ROK's view regarding WP25 Presented by Japan

1-5 November 2021 | Republic of Korea

Ministry of Land,
Infrastructure and Transport

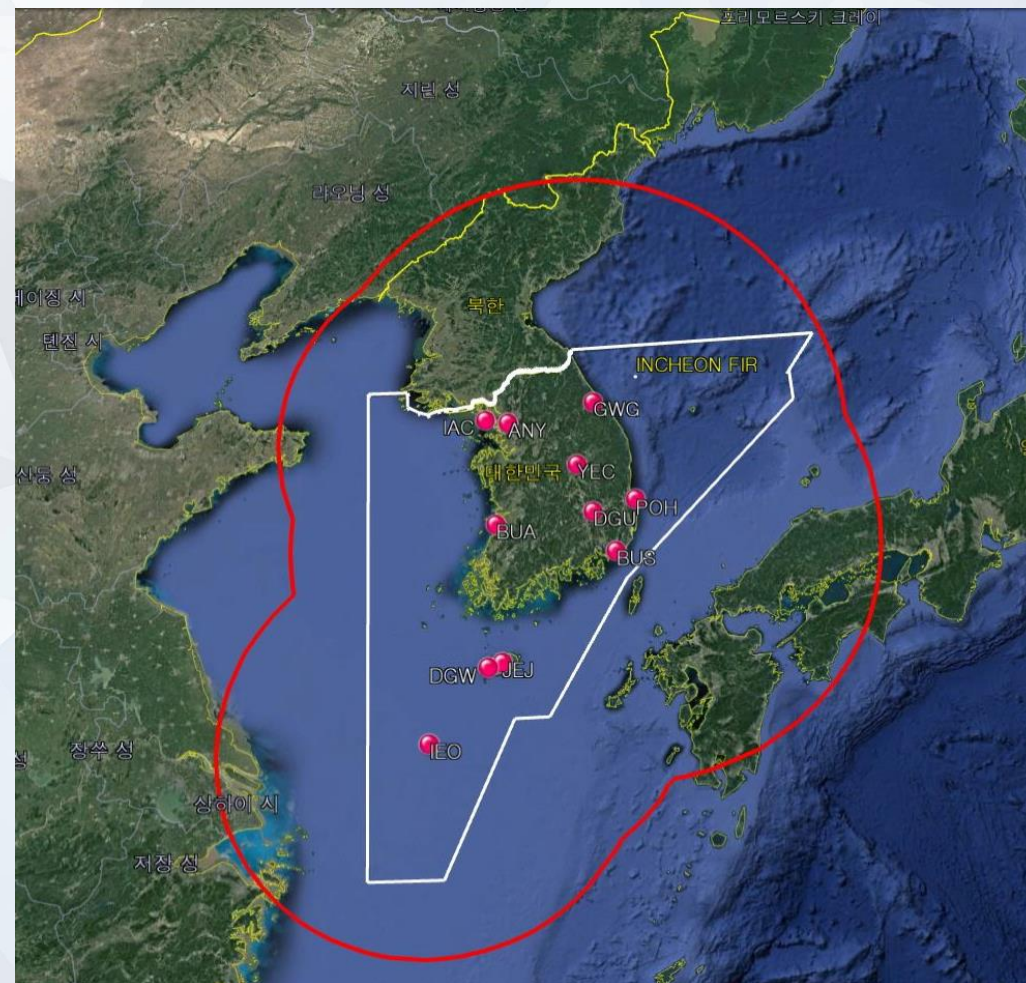
❖ Crossing points (PONIK, NIRAT) are located within 50NM of the FIR boundary.

❖ Incheon ACC has full coverage of ATS surveillance over the whole Incheon FIR, however, ATS surveillance data is not exchanged between Incheon ACC and Fukuoka ACC.

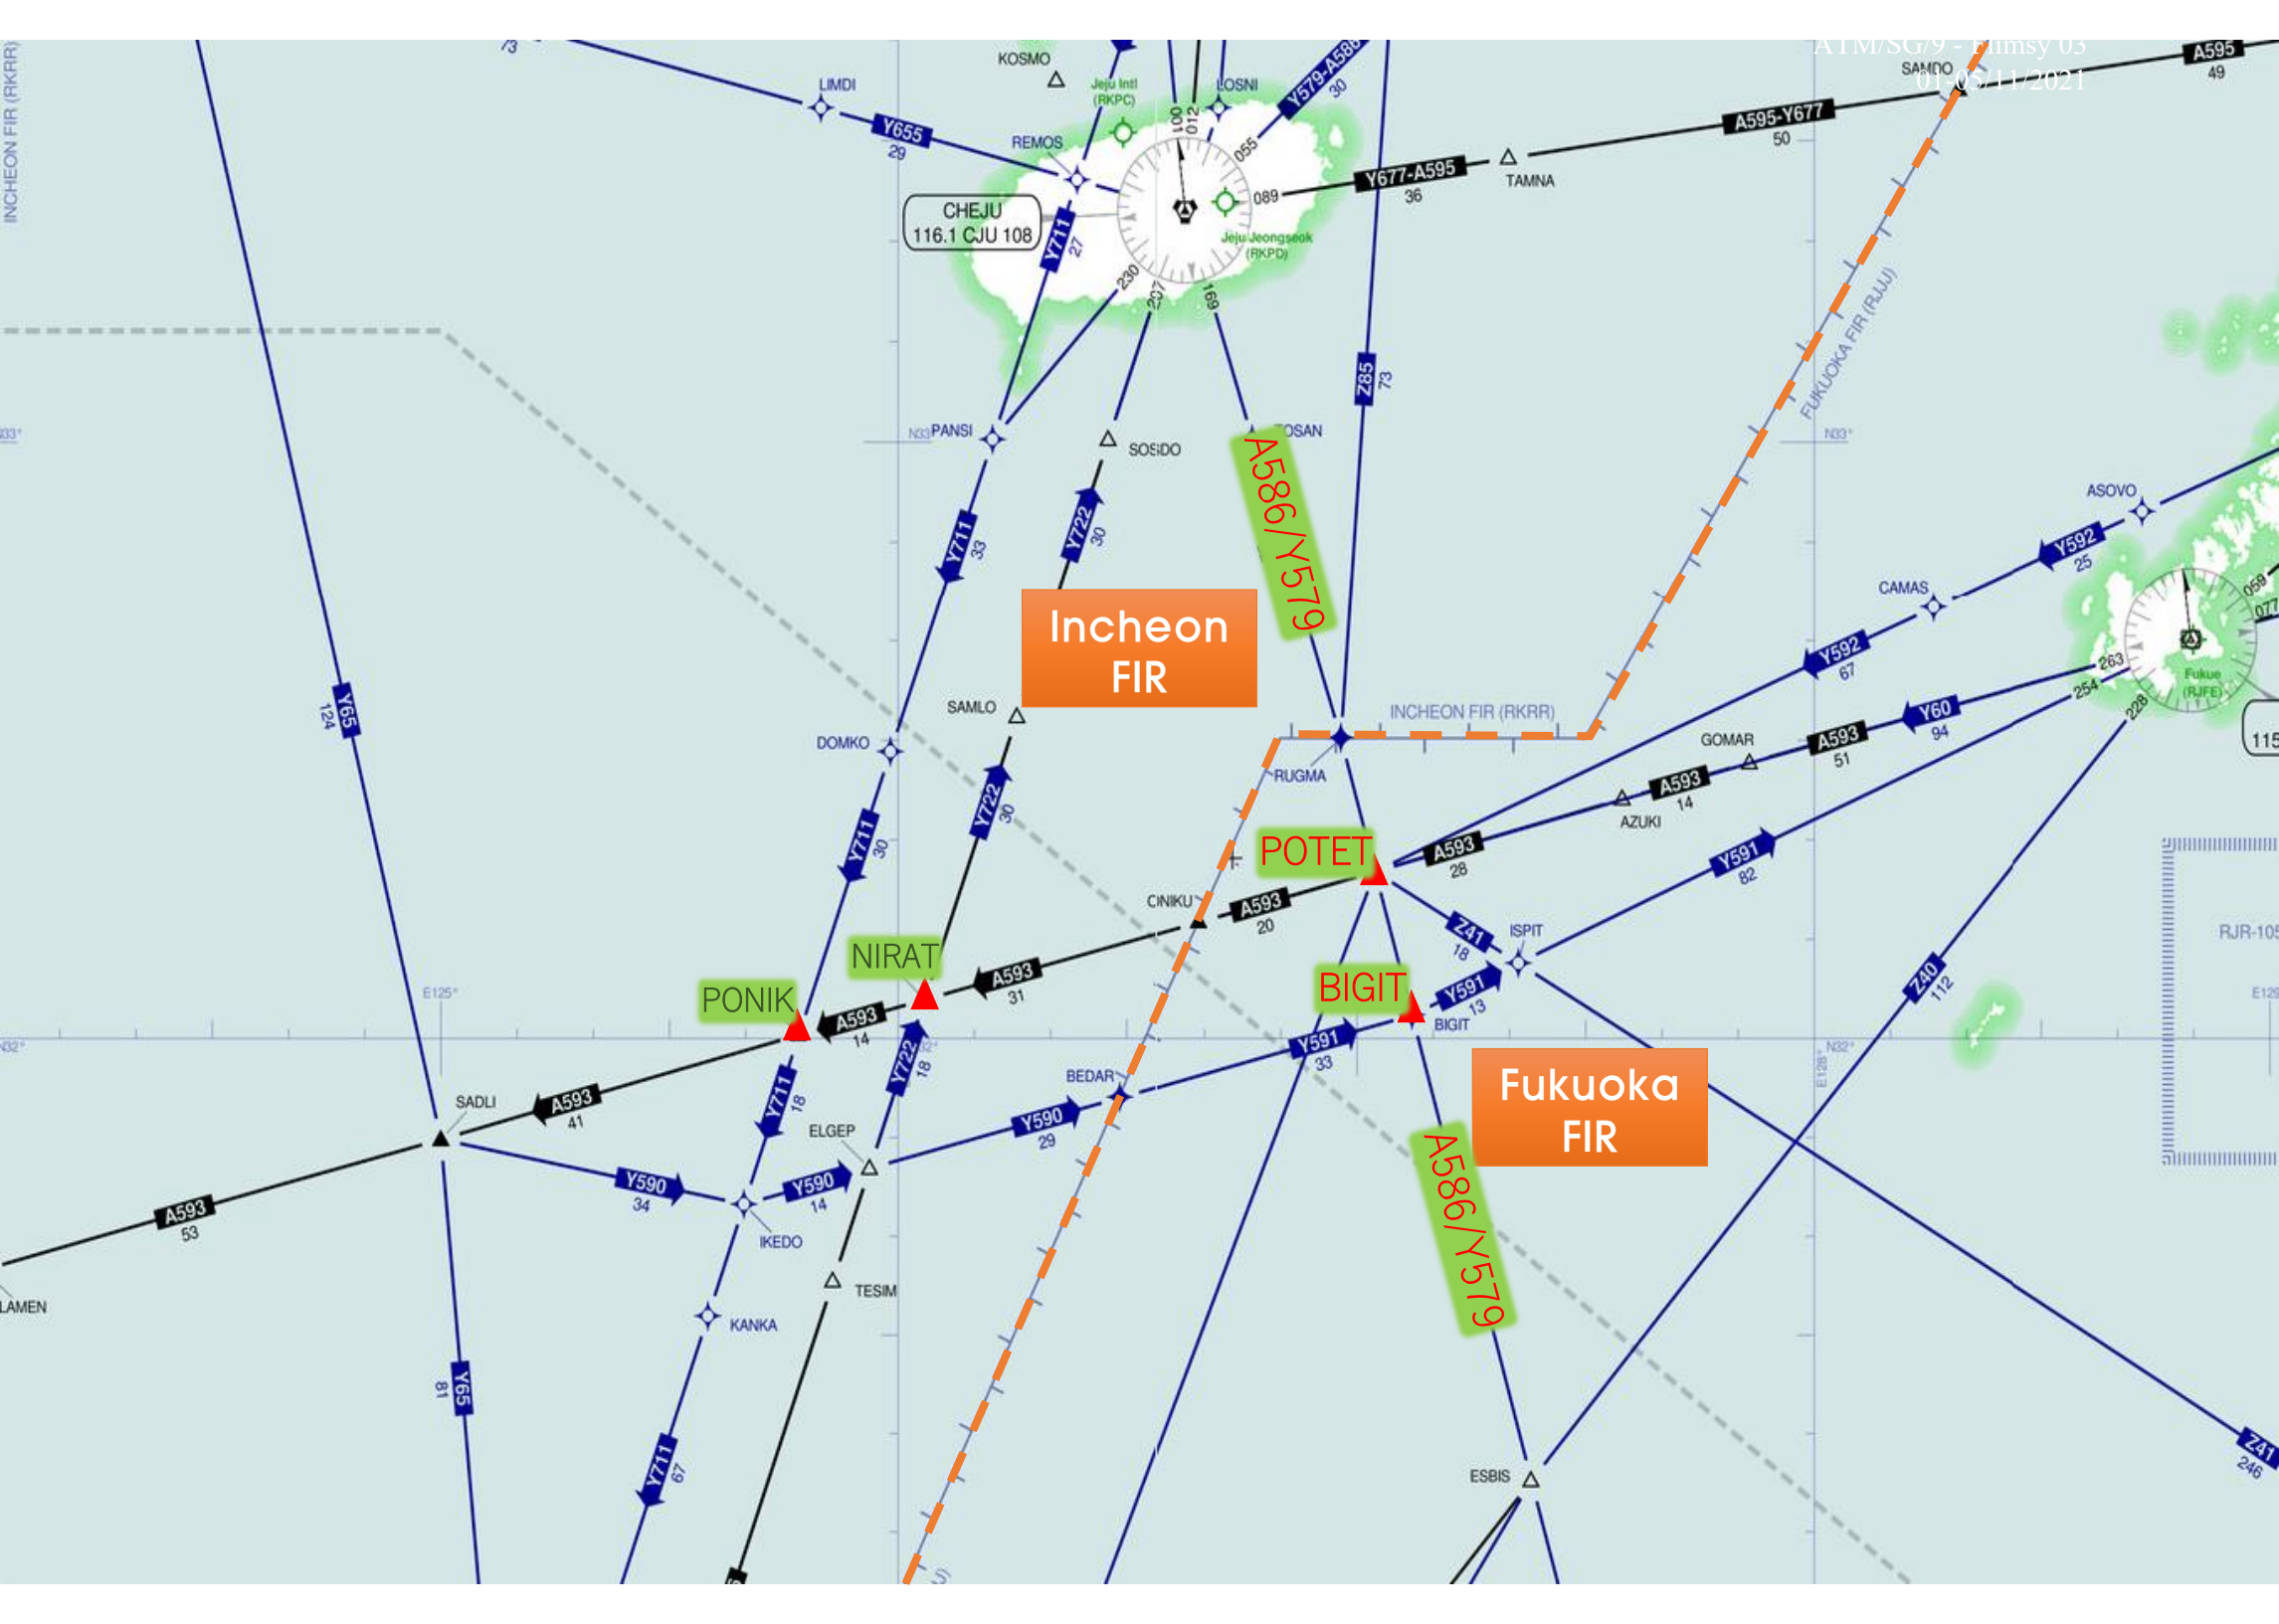
2.10 As a side note, there are similar intersection points within Fukuoka FIR too. Those points exist very close to the edge of the AKARA corridor airspace, the FIR boundary between Fukuoka FIR and Incheon FIR. Japan never implements FLAS at the crossing points since changing altitude from/to the FLAS altitude is believed to cause increasing ATC workload and decreasing safety and efficiency of aircraft operators. Besides, the ATS surveillance capability of Fukuoka ACC well covers around the FIR boundary between Fukuoka FIR and Incheon FIR.

- ❖ It is believed that those points which are very close to FIR boundary between Fukuoka FIR and Incheon FIR are “POTET” and “BIGIT”.
